ITEM: 6.7	REPORT SUMMARY MINOR VARIANCE APPLICATION FILE NUMBER A066/25
-----------	---

## MINOR VARIANCE APPLICATION FILE NUMBER A066/25

<b>CITY WARD #:</b>	1
<b>APPLICANT:</b>	Rahul & Shikha Goel
<b>AGENT:</b>	Andrew Solari (Bancheri Bros. Interlock Paving Corp.)
<b>PROPERTY:</b>	321 Woodgate Pine Drive, Kleinburg
<b>ZONING DESIGNATION:</b>	See Below
<b>VAUGHAN OFFICIAL PLAN (2010) DESIGNATION:</b>	Vaughan Official Plan 2010 ('VOP 2010'): "Low Rise Residential"
<b>RELATED DEVELOPMENT APPLICATIONS:</b>	N/A
<b>PURPOSE OF APPLICATION:</b>	Relief from the Zoning By-law is being requested to permit a proposed cabana in the rear yard.

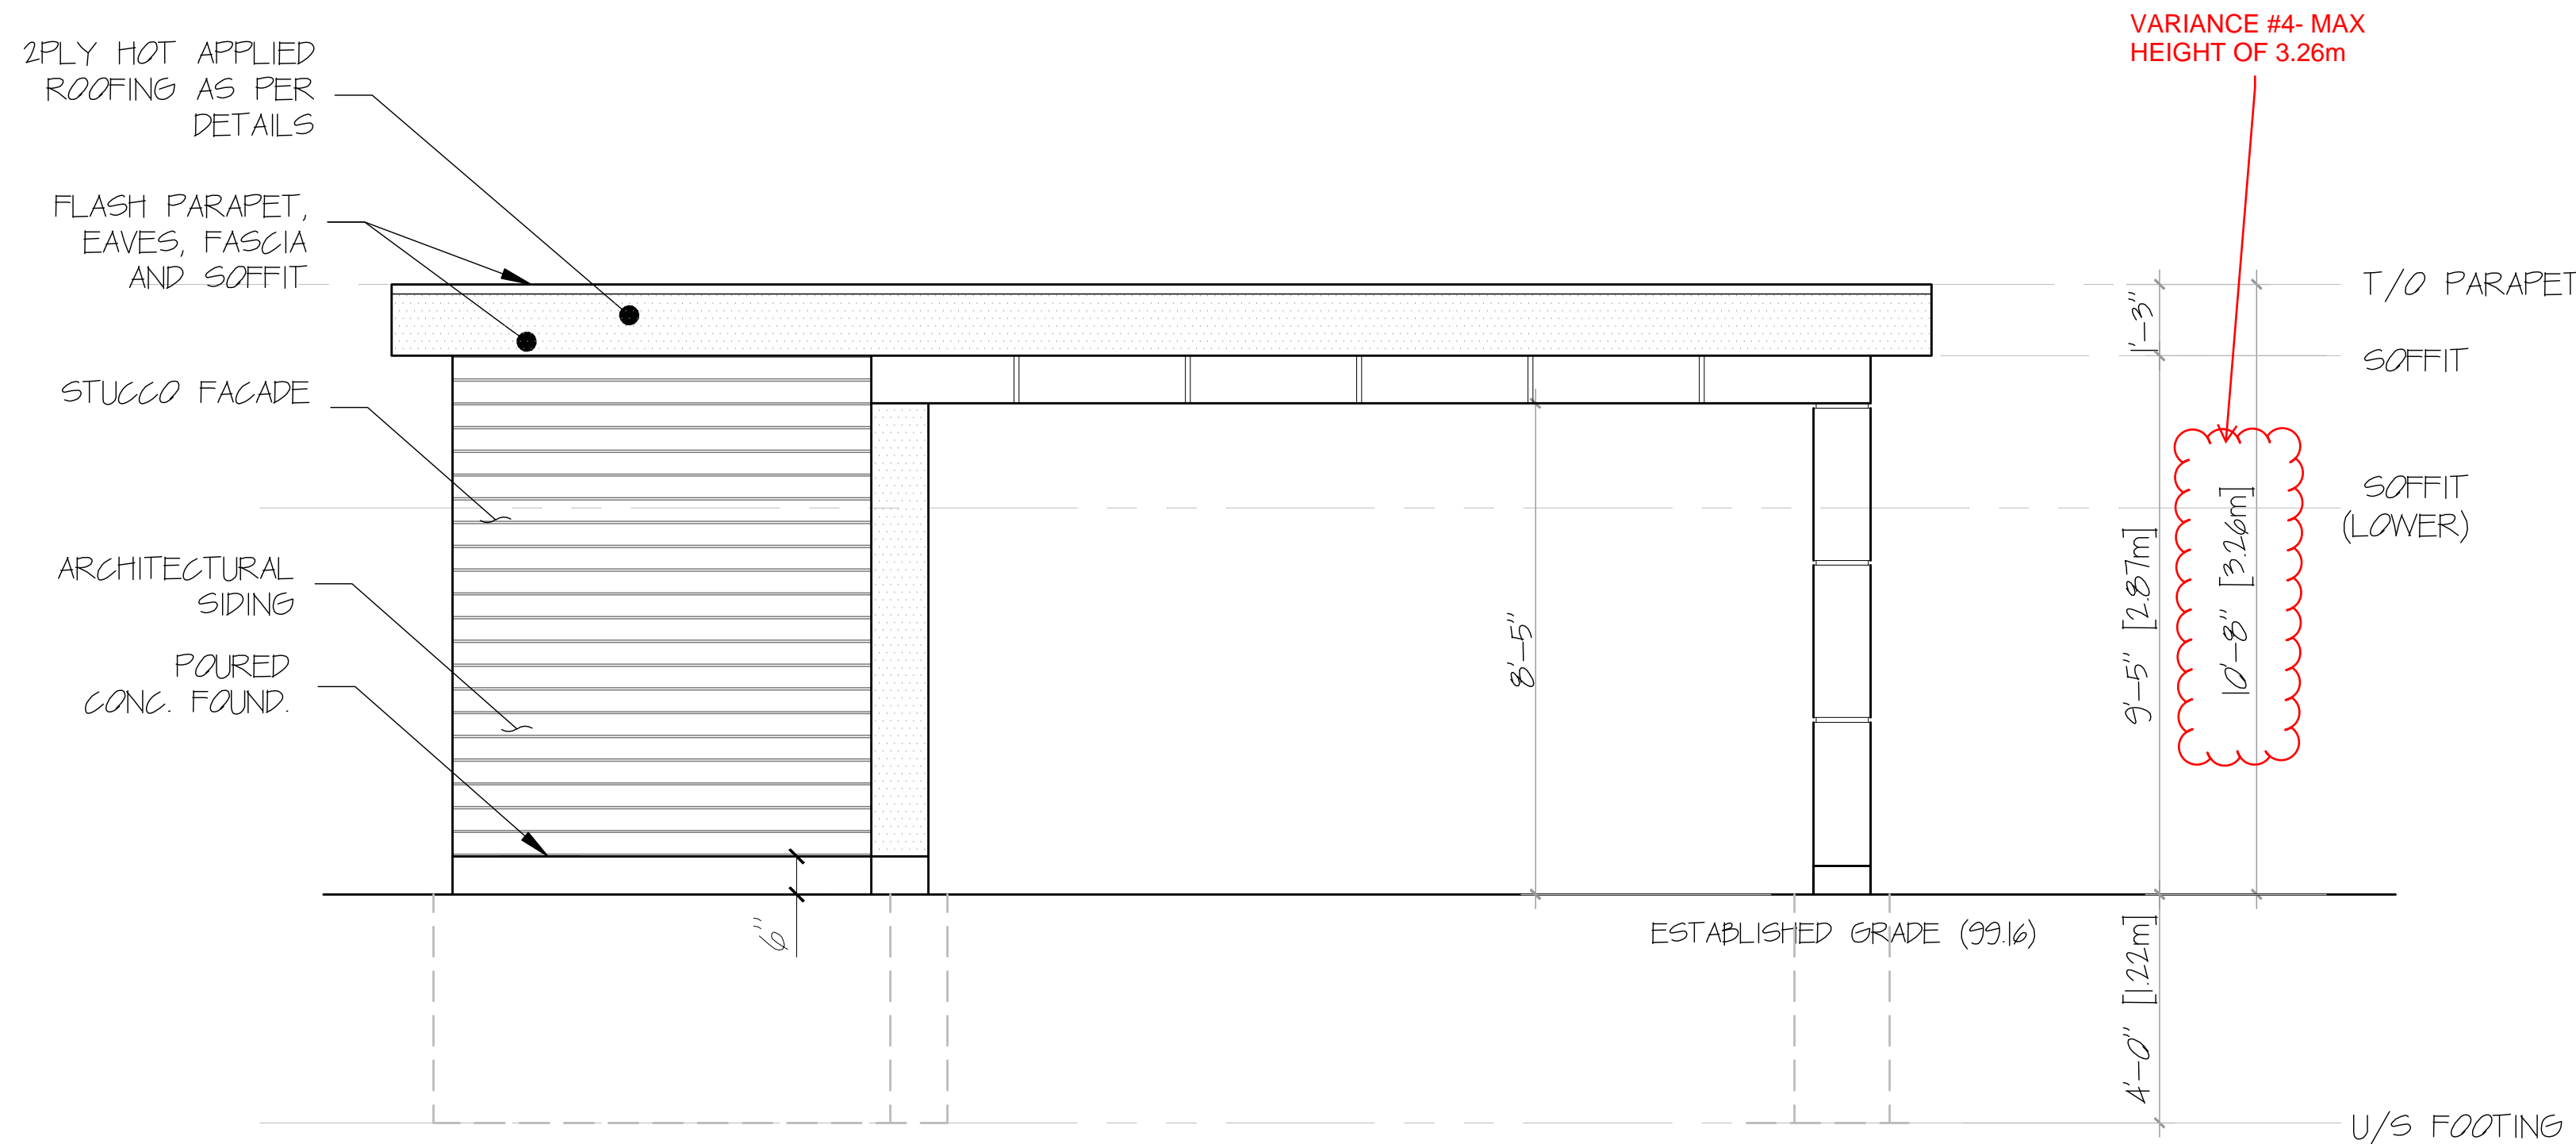
The Development and Parks Planning Department has no objections to Variance 1 to reduce the minimum required soft landscaping for the portion of the rear yard in excess of 135 m<sup>2</sup> from 60% to 51.90%. The reduction represents approximately 20 m<sup>2</sup> of soft landscaping. Development Engineering staff have reviewed the proposed reduction and have no concerns with the proposed soft landscaping percentage and do not anticipate any impacts on the stormwater management functions of the rear yard. The requested variance is minor and meets the intent of the zoning provision.

The Development and Parks Planning Department has no objections to Variances 2 and 3 to reduce the rear and interior side yard setbacks to accommodate the proposed cabana. The location of the proposed cabana is not parallel to the rear and westerly interior side lot lines. The proposed setbacks of 1.22 m and 1.0 m expands to 1.99 m and 1.5 m toward the east and rear of the cabana. The proposed setbacks provide sufficient separation for access and maintenance.

ELEVATIONS I

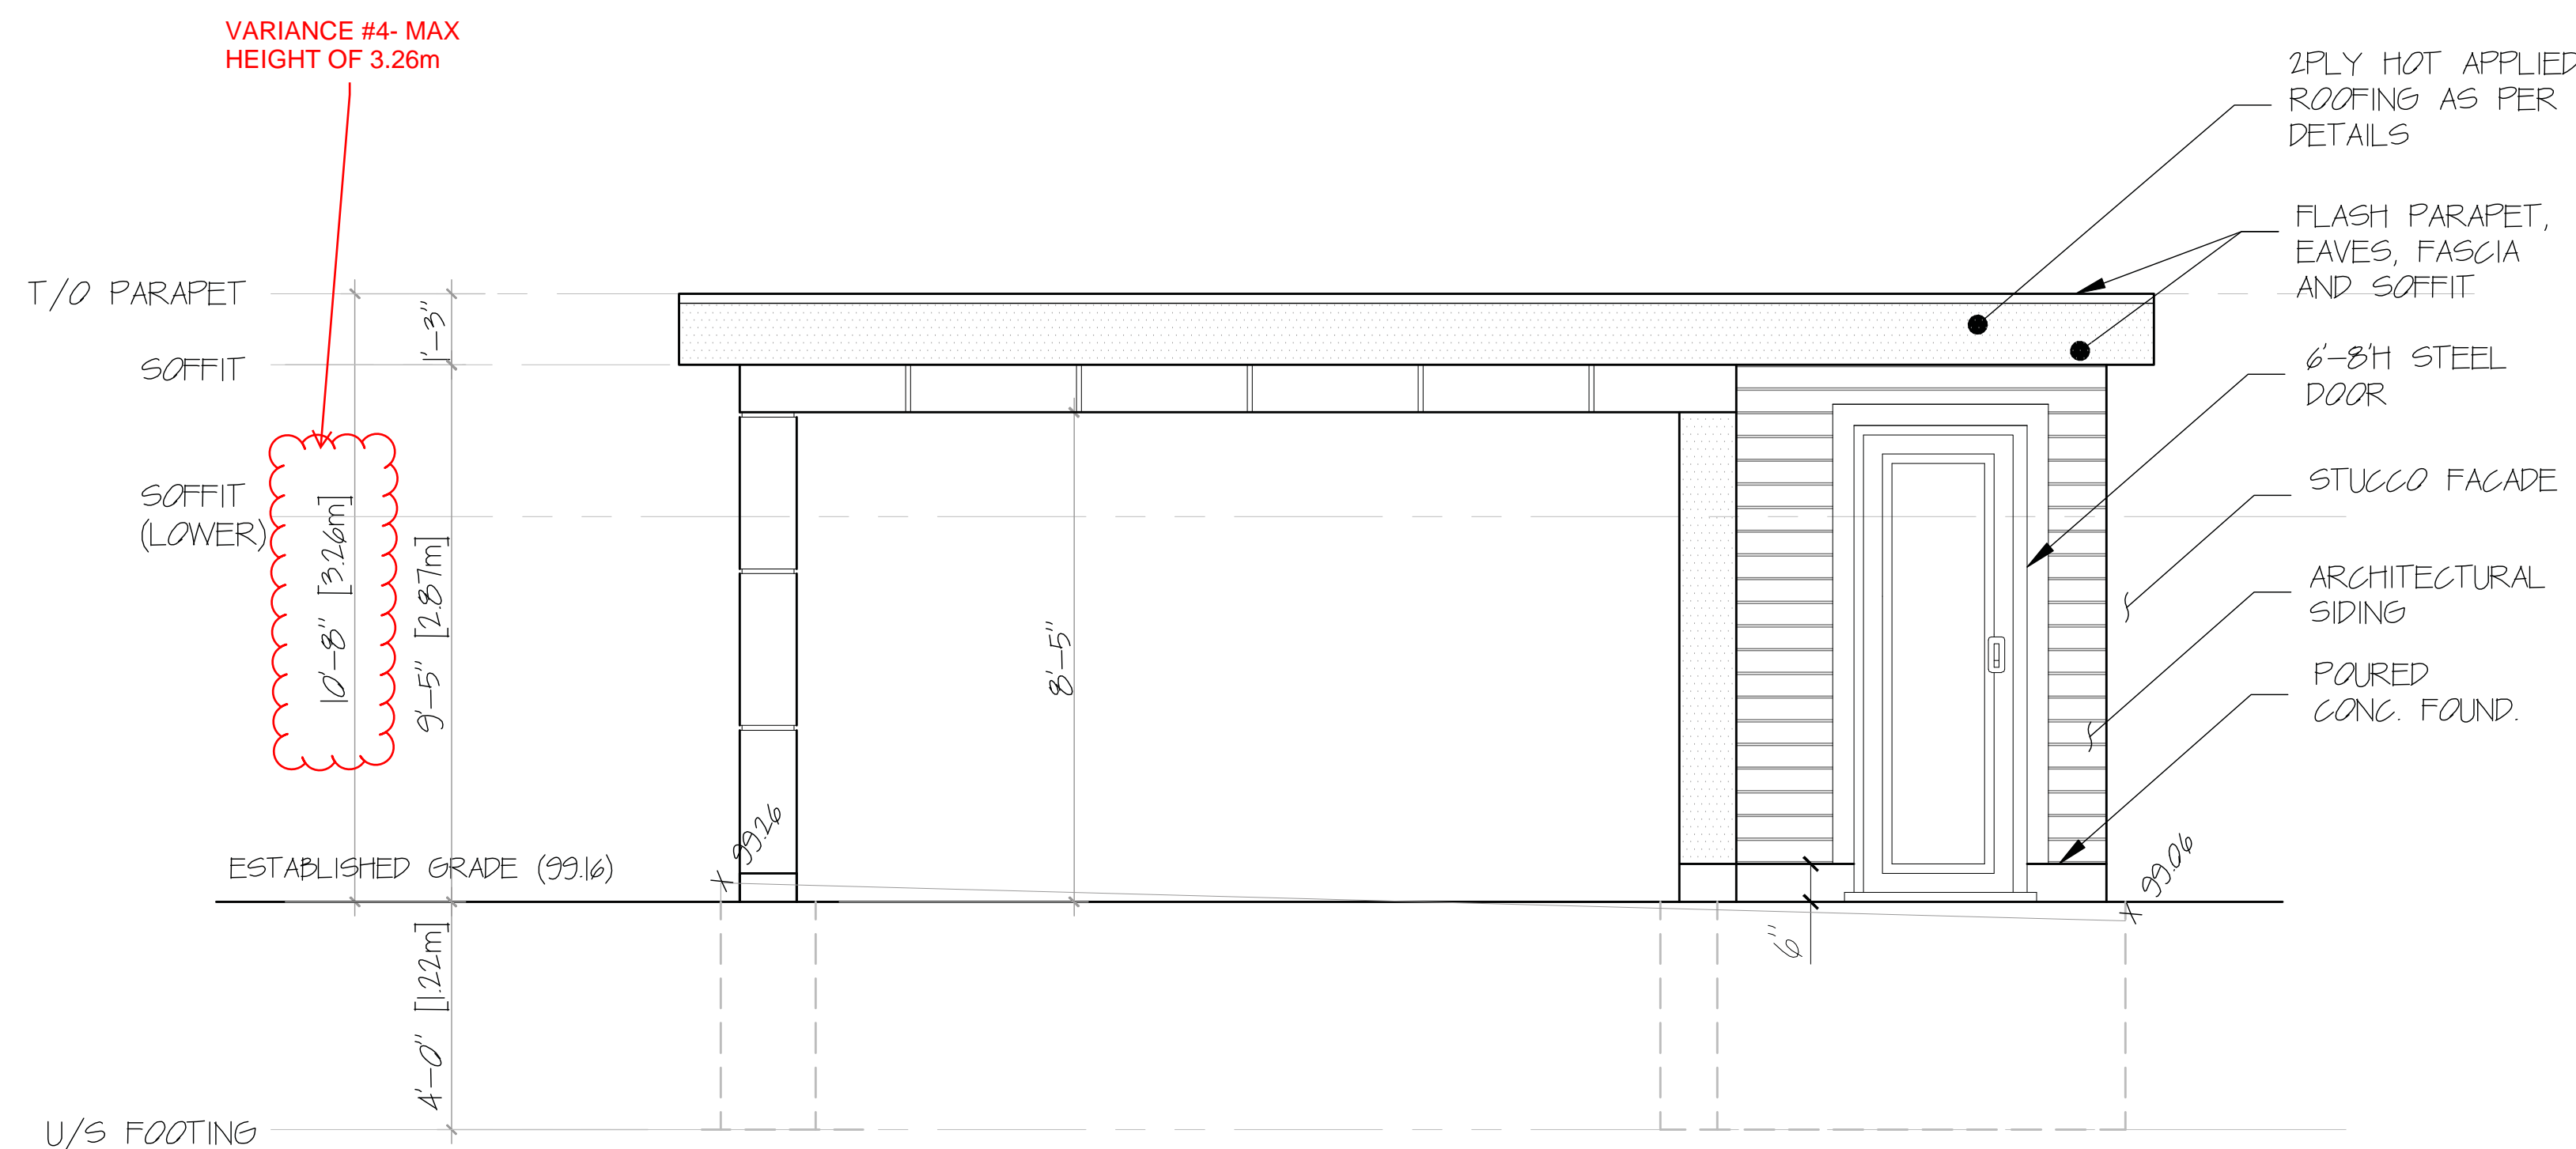
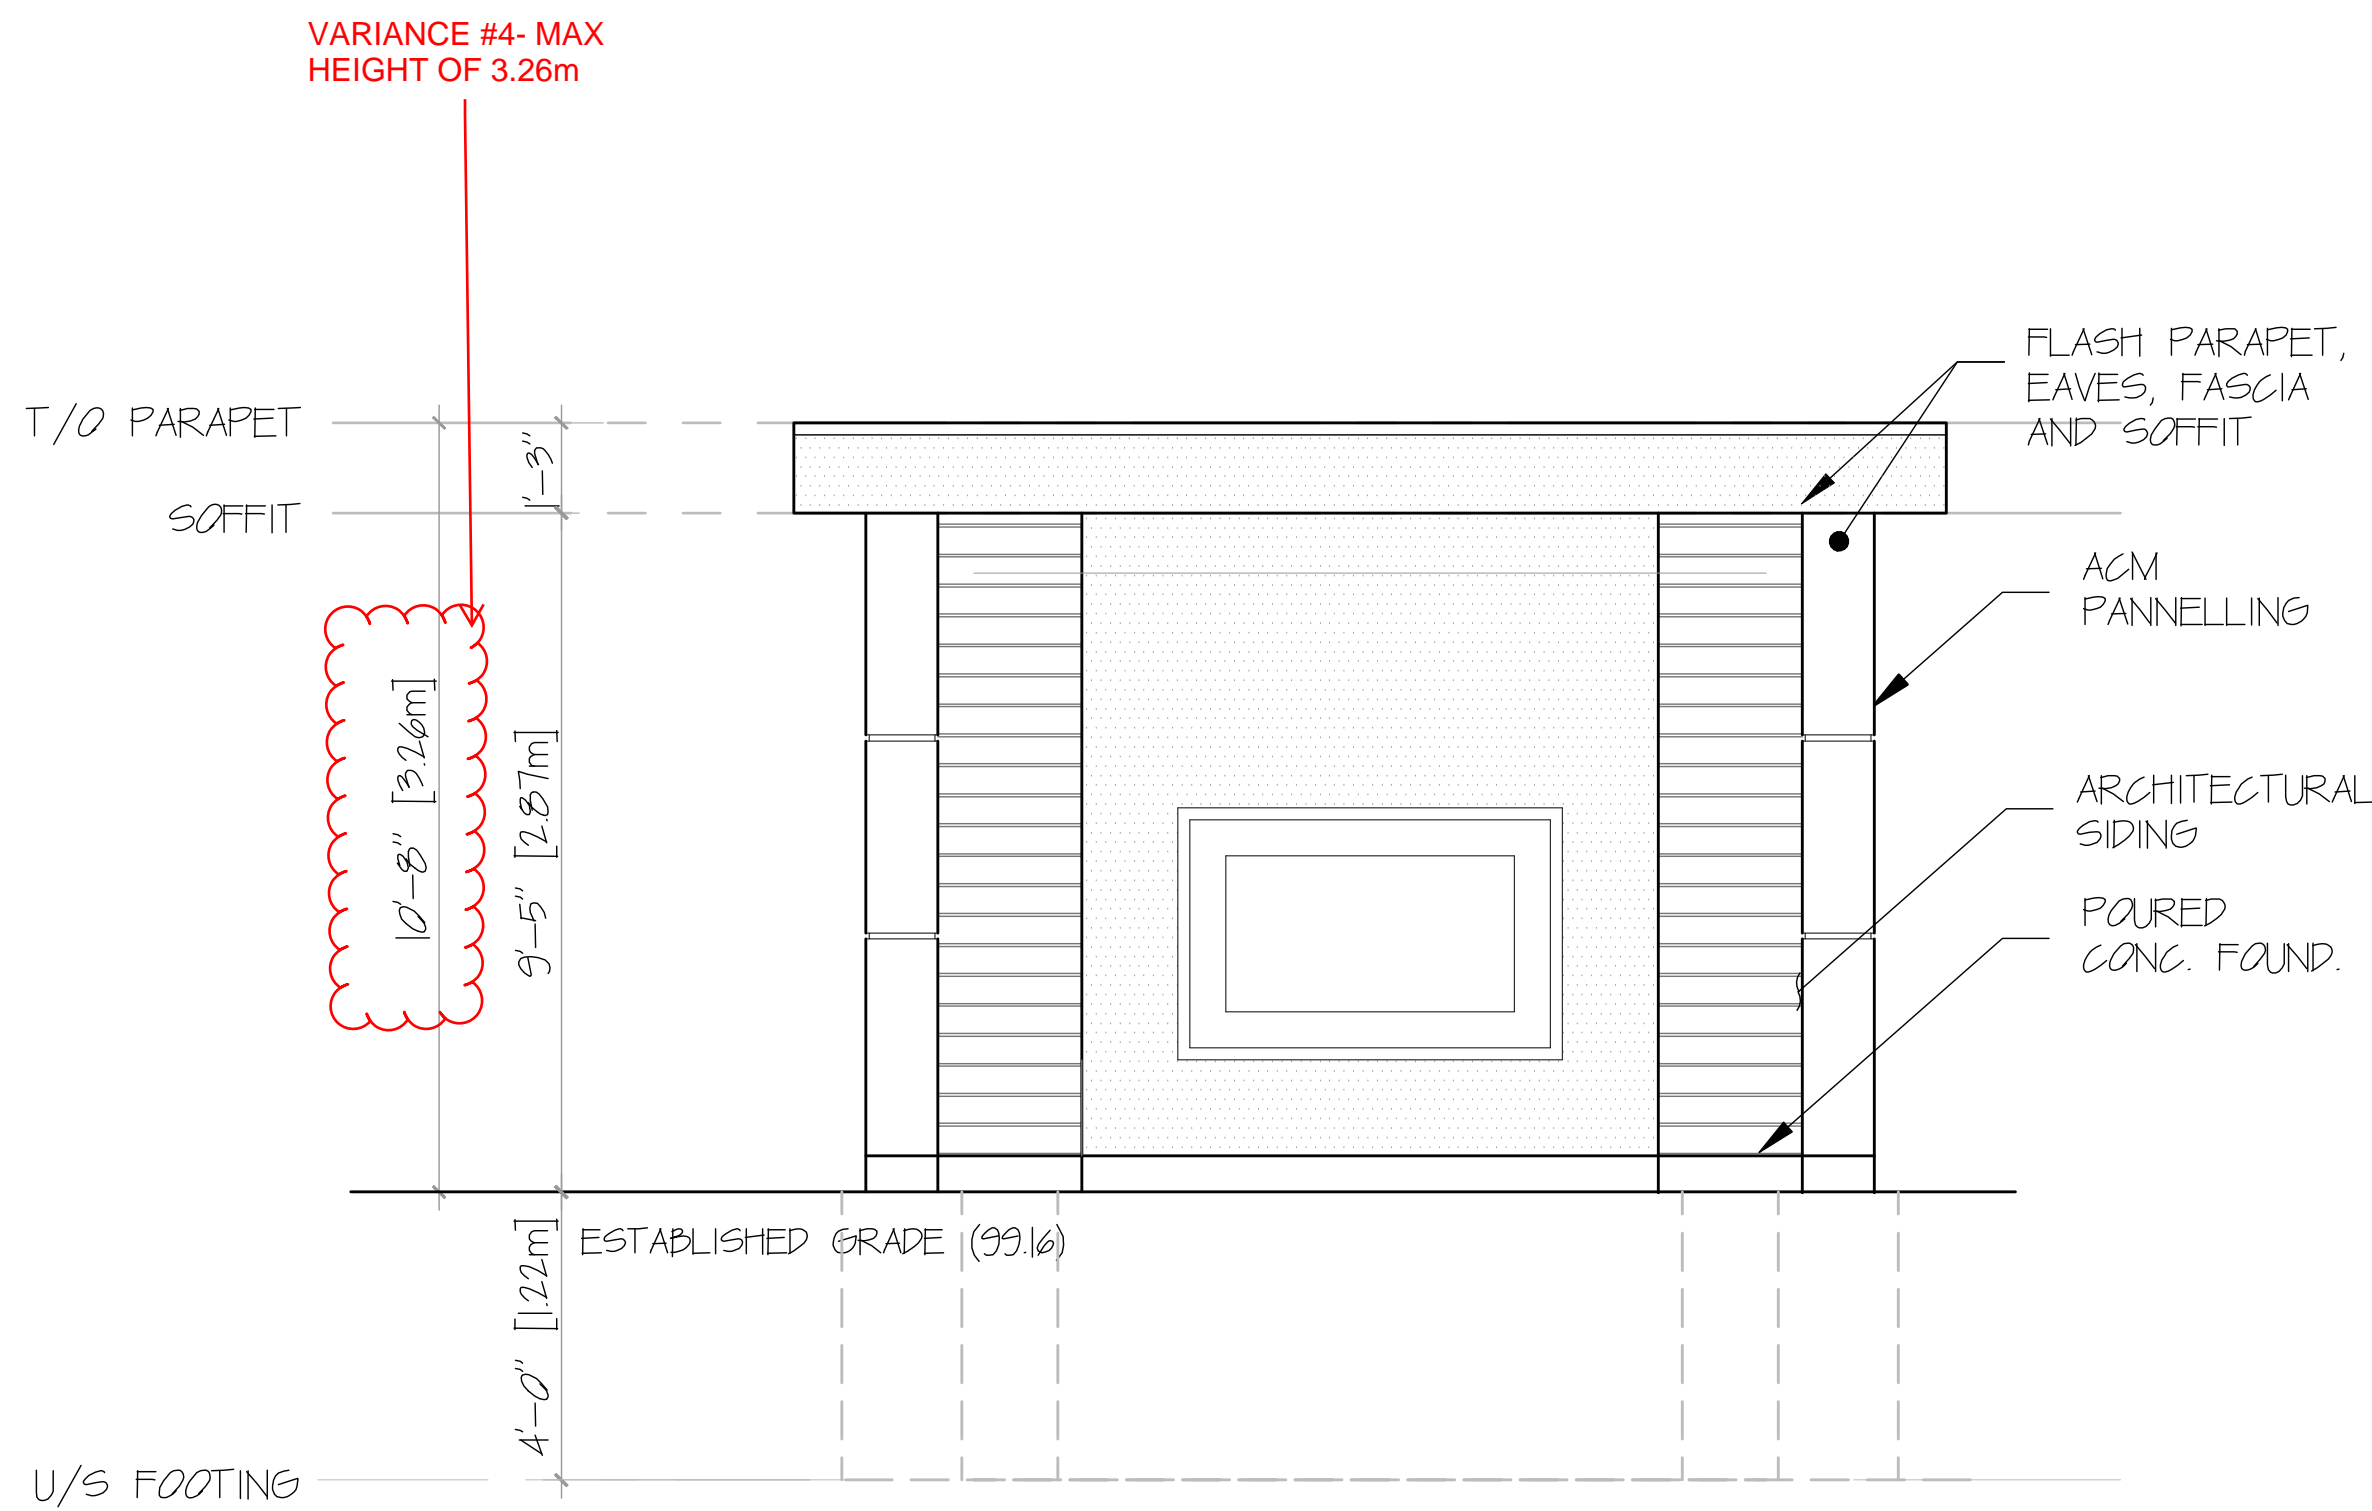
The Development and Parks Planning Department has no objections to Variance 4 to permit an increased height of the proposed cabana from 3.0 m to 3.26 m. The majority of the cabana is unenclosed, which minimizes massing impacts on neighbouring properties. The proposed cabana is compliant with lot coverage and is not anticipated to incur any negative impacts on the neighbouring properties.
